Duke Power Company  
Oconee Nuclear Station

Attachment 1

Proposed Technical Specification Revision

No Significant Hazards Consideration Evaluation

Figure 6.1-1

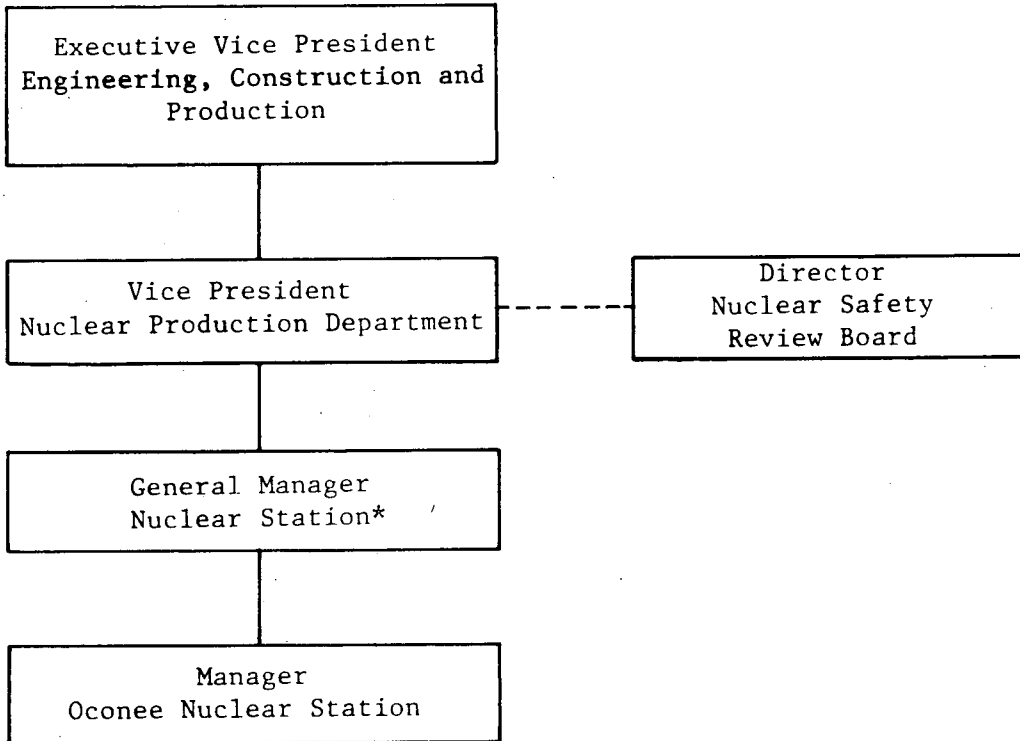
The final revisions are updates to the Station Organizational Chart and Management Organization Chart, for Oconee Nuclear Station, to achieve consistency with Duke Power's current organization.
